Village of Arlington Heights
Plan Commission
Buechner Room, 1st Floor
Arlington Heights Village Hall
33 S. Arlington Heights Road
Arlington Heights, IL 60005
October 13, 2016
7:30 PM

- A. Thomas Middle School - 1430 N. Belmont Ave. - PC#16-020
Special Use for a School, Multiple Variations

RE: ARLINGTON ALE HOUSE - 111 WEST CAMPBELL STREET, 3RD FLOOR
PC# 16-019, SPECIAL USE FOR RESTAURANT, LAND USE VARIATION

C4.1

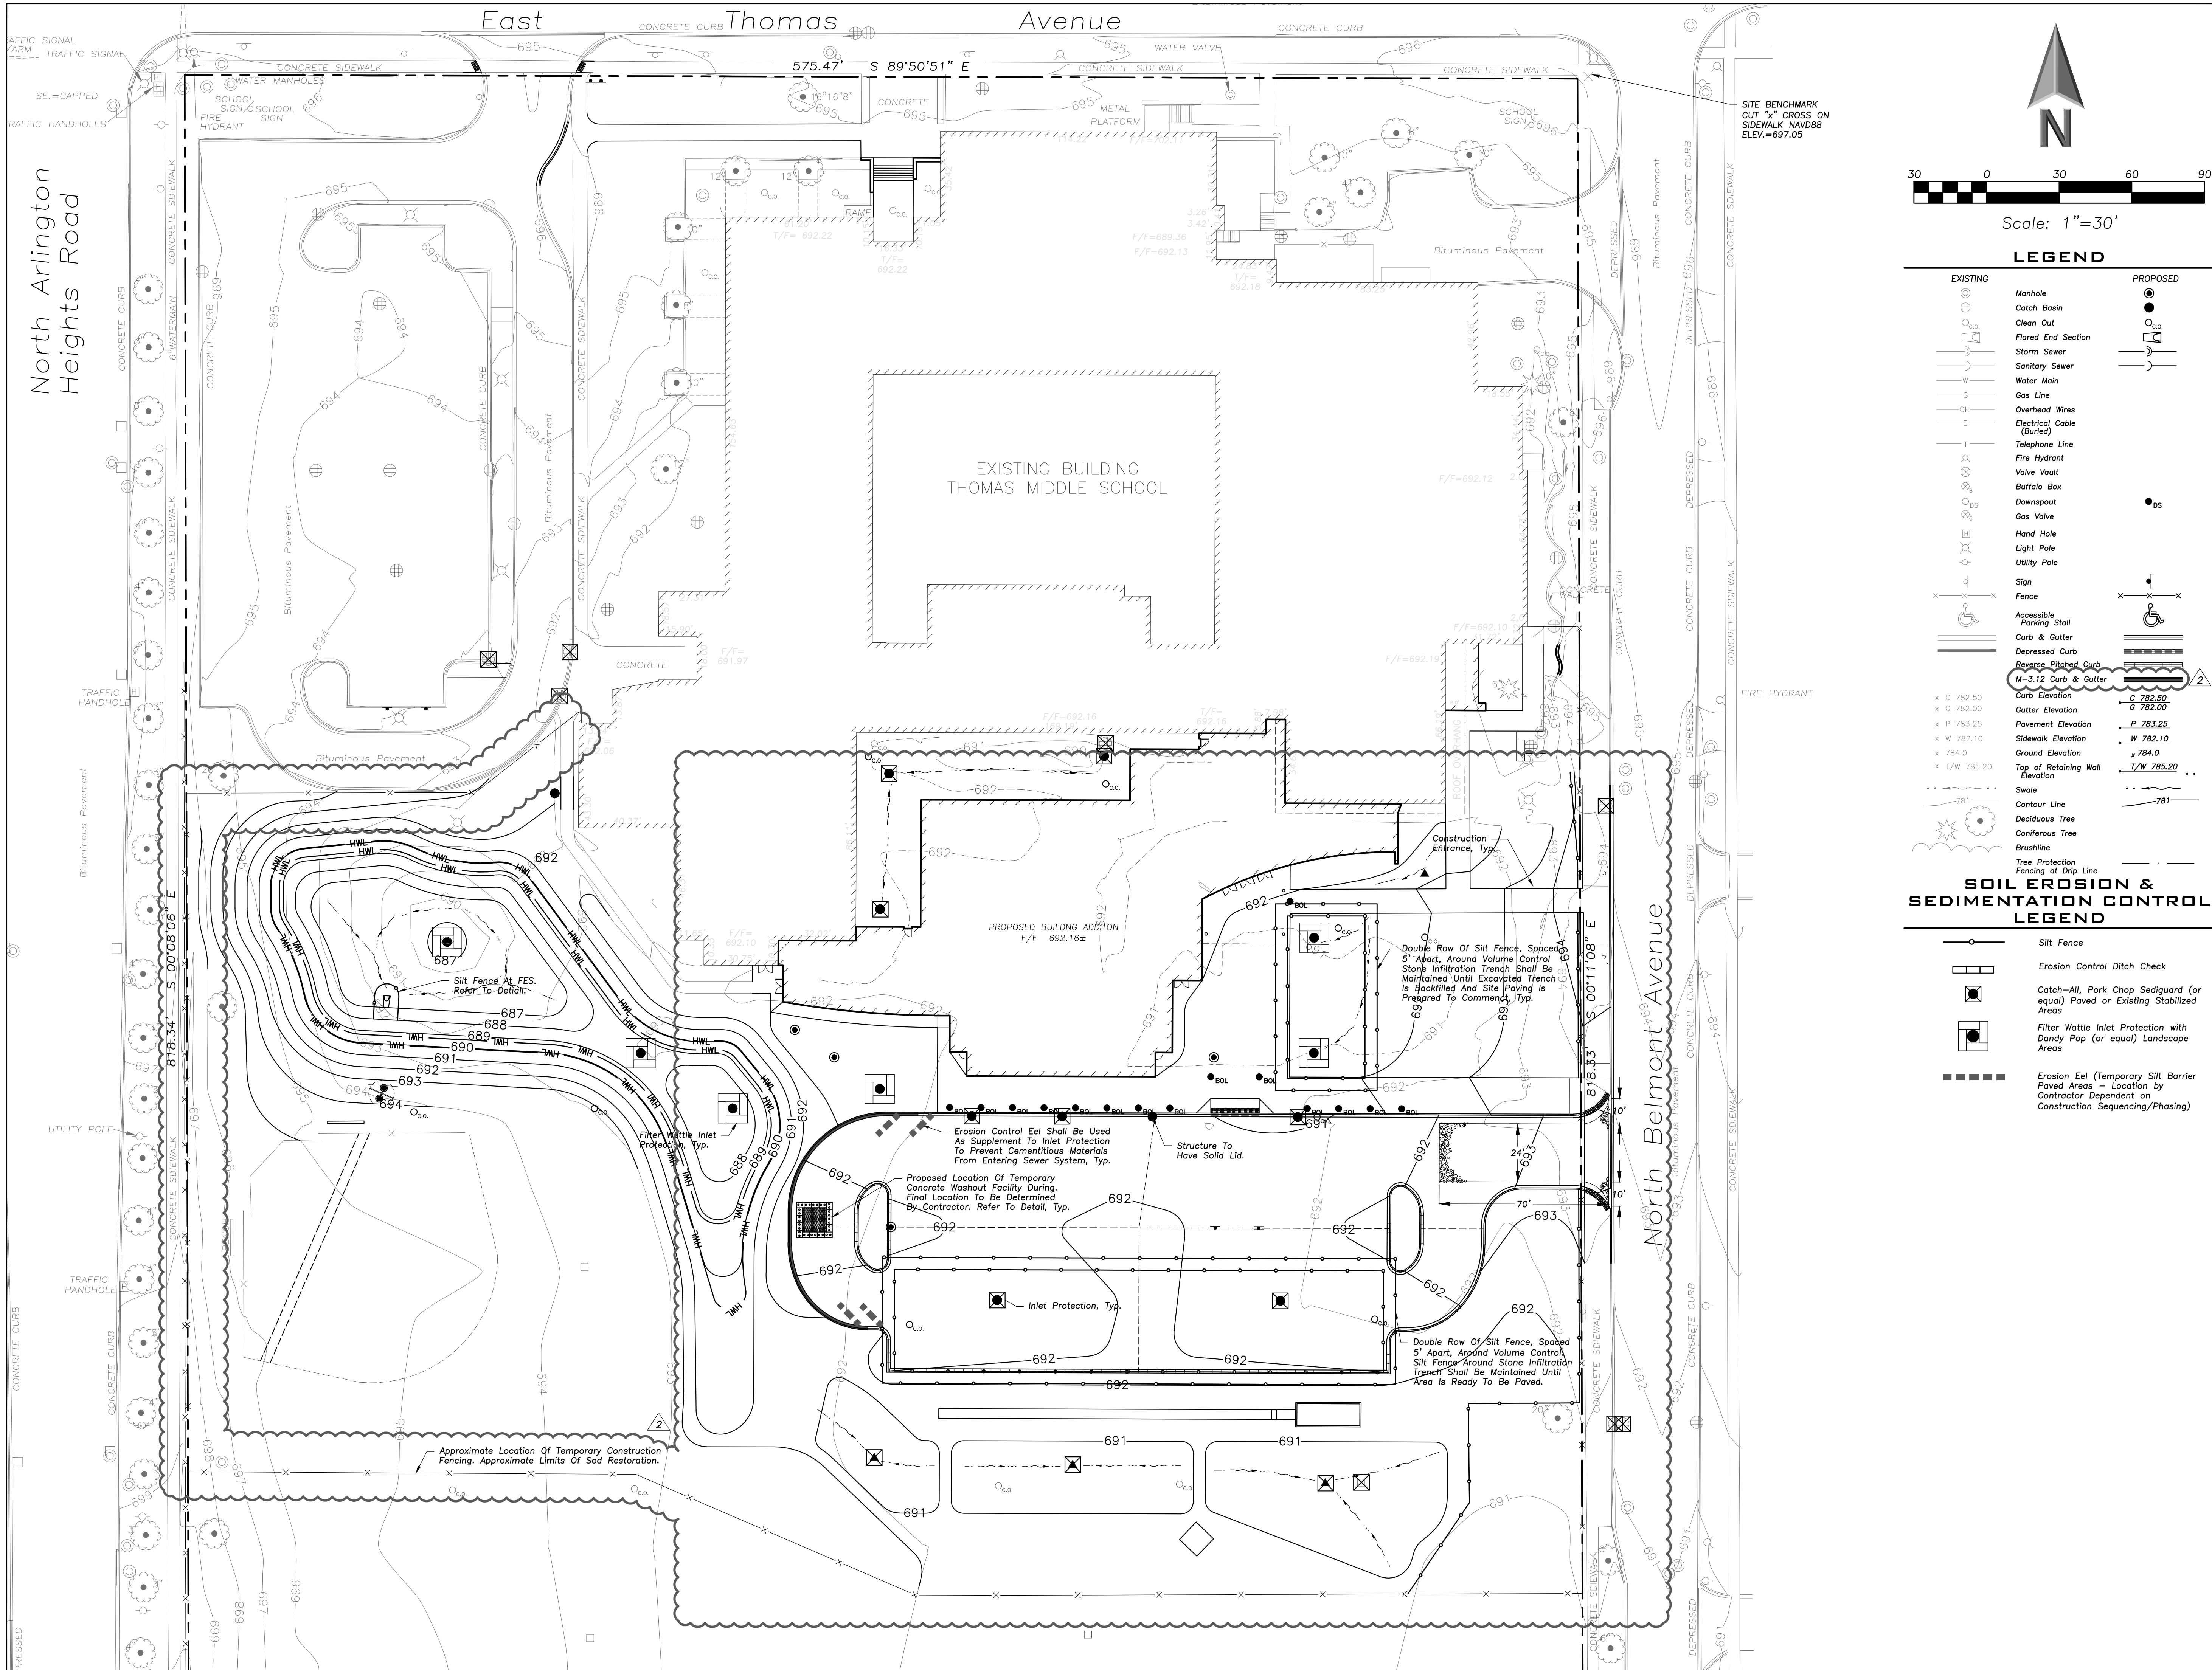
20. Sheet C4.1: The HWL in the east pond is shown at elev=689.16, not at the actual HWL of 690.16. Double check detention calculations.
21. Sheet CX2.1: Show the extent of the front and rear overhangs of the fire vehicle. Remove the bus lines from this exhibit, since there is a separate exhibit for the bus.

20. Sheet C4.1: The HWL in the east pond is shown at elev. =689.16, not at the actual HWL of 690.16. Double check detention calculations.

The Heavy-Duty (Fire Lane) Asphalt Pavement Section shown in the Paving & Surface Legend on Sheet C4.1 has been revised. Notes to omit the welded wire fabric in the public ROW have also been added to the legend.

CX2.1

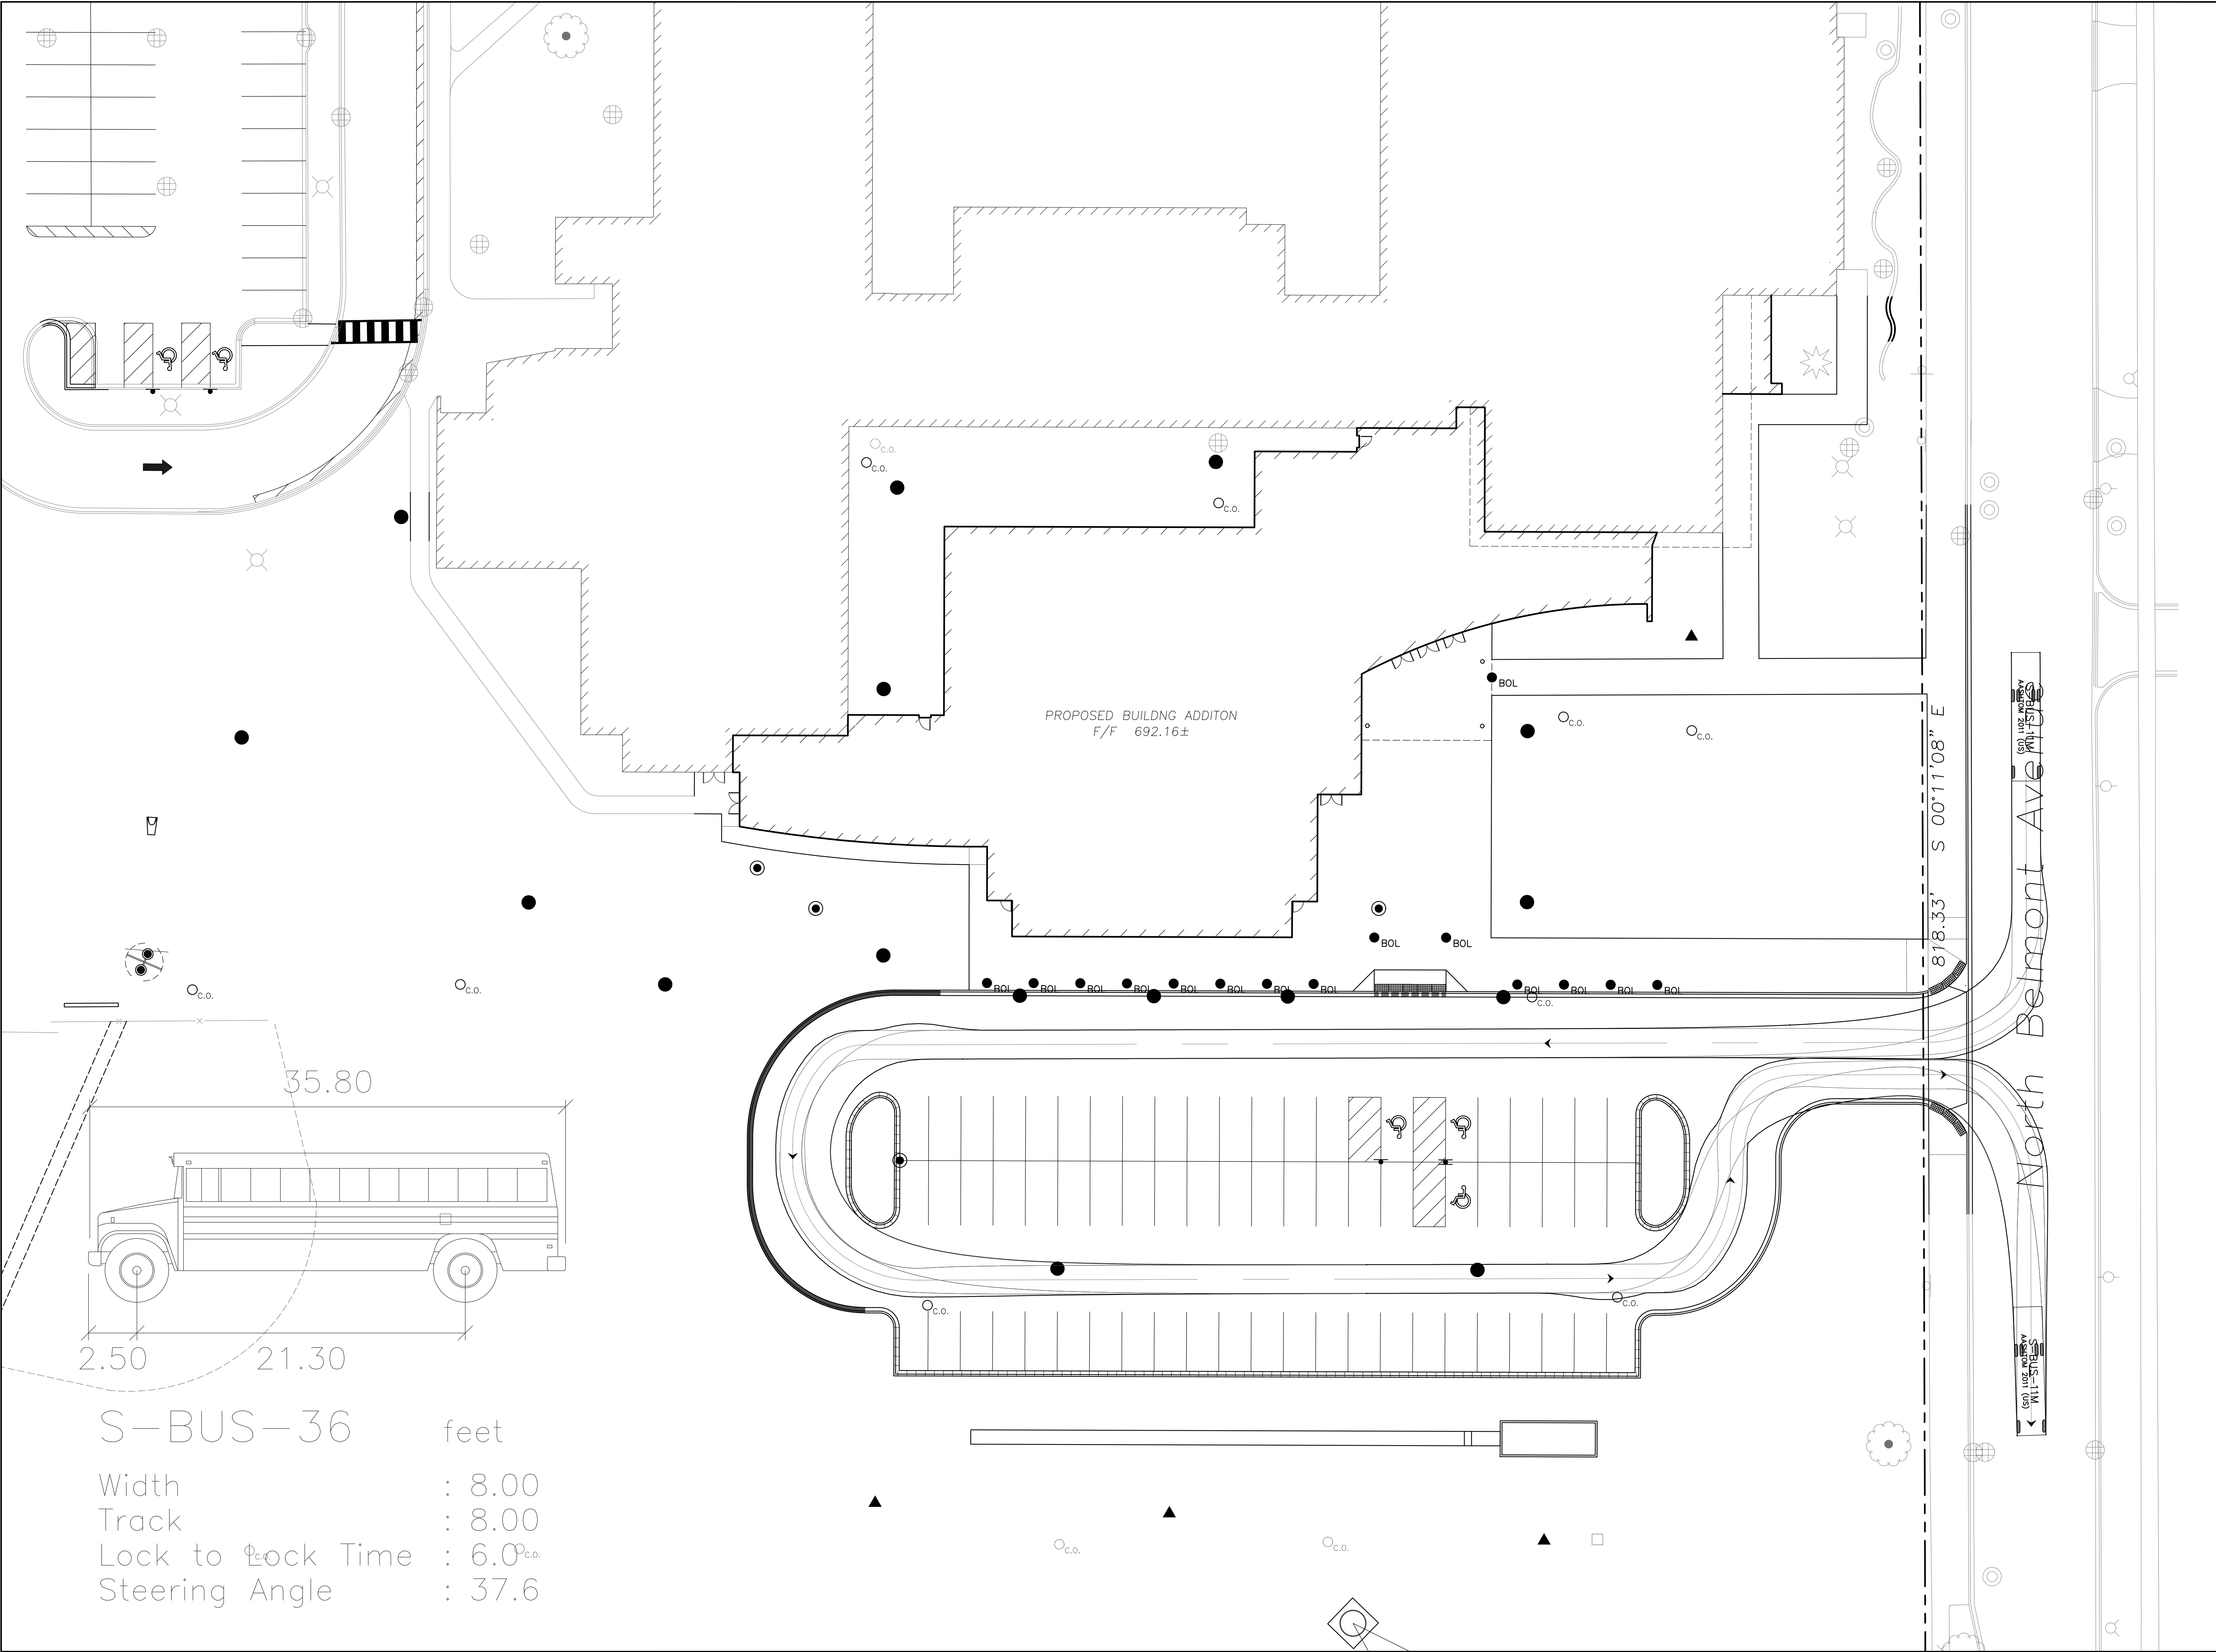
21. Sheet CX2.1: Show the extent of the front and rear overhangs for the fire vehicle. Remove the bus lines from this exhibit, since there is a separate exhibit for the bus.

Sheet No:
CX2.2

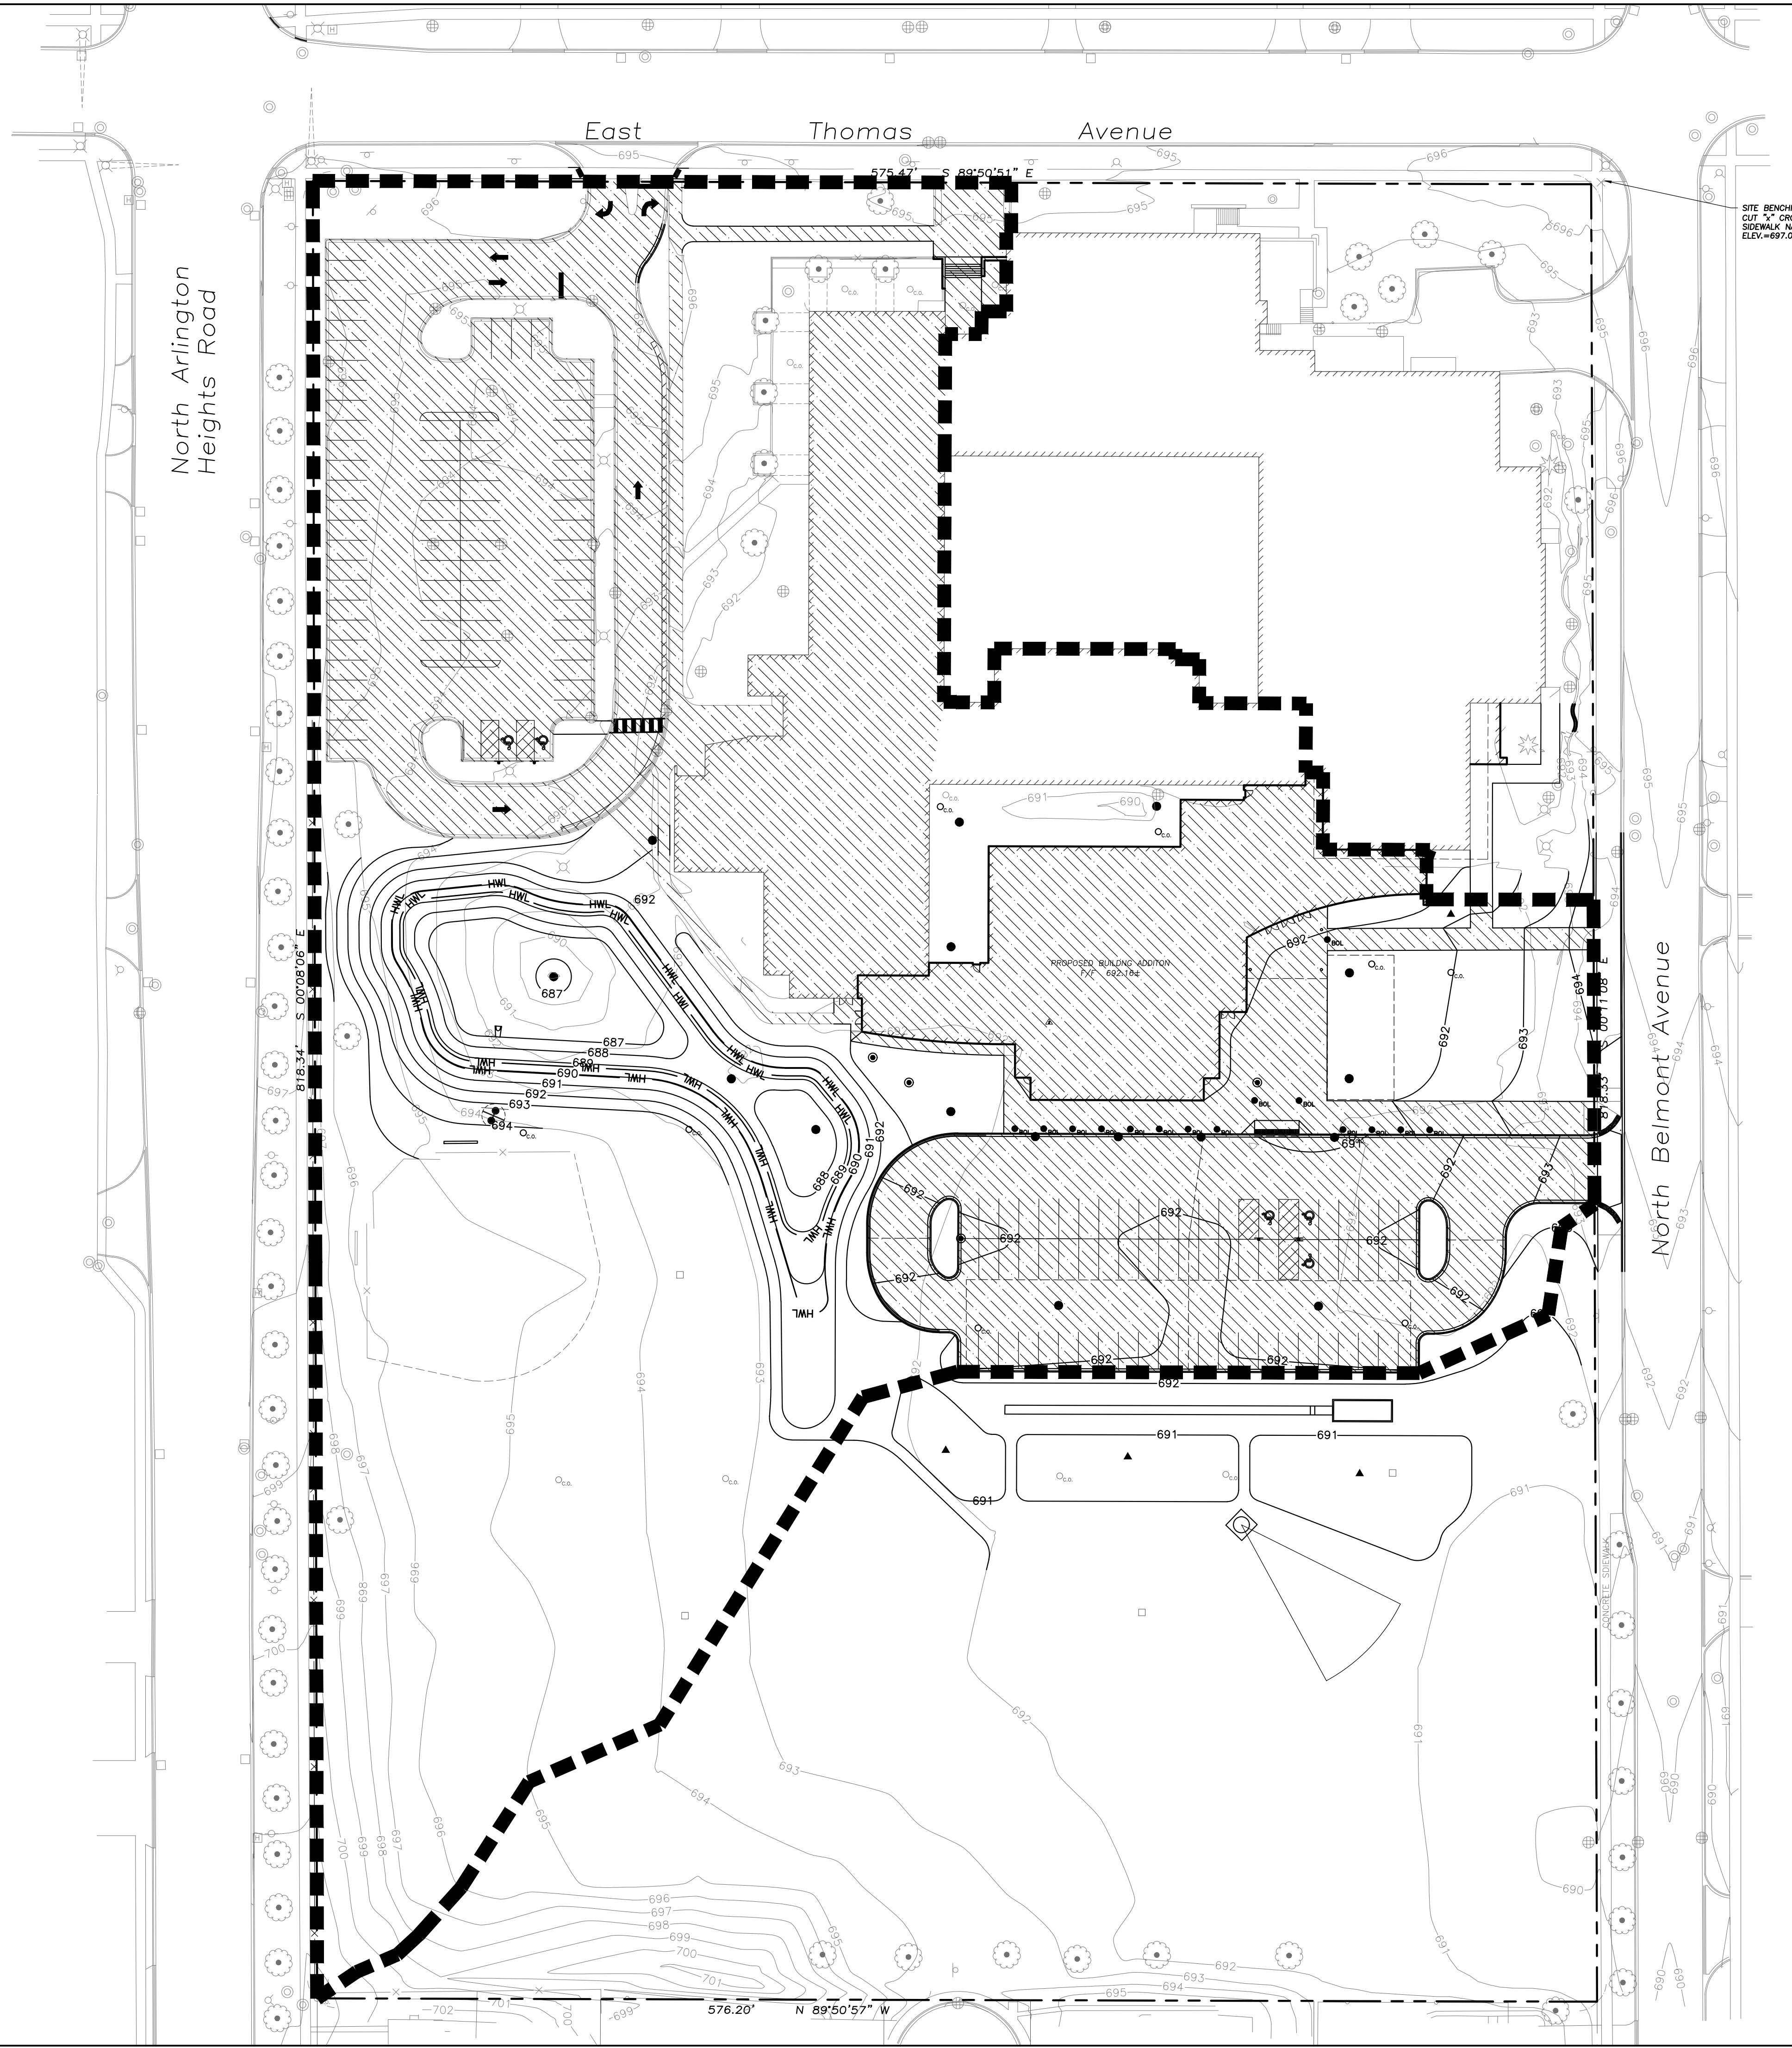
22. Sheet CX2.2: Show the extent of the front and rear overhangs of the bus.
